Service Bulletin

Subject: Improved Braided Flexline Replacements

Models: Fryers with Filtration

10/2/2025

Figure 1

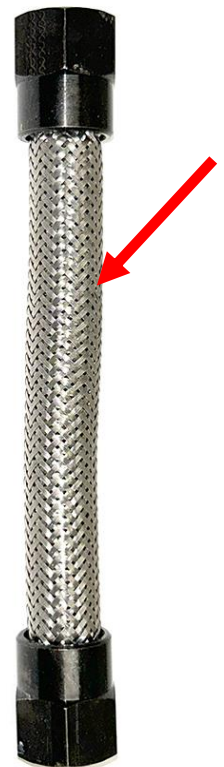
Whenever replacing flexlines, use a backup wrench on the adaptor to prevent loosening and torsional twisting of the flexline.
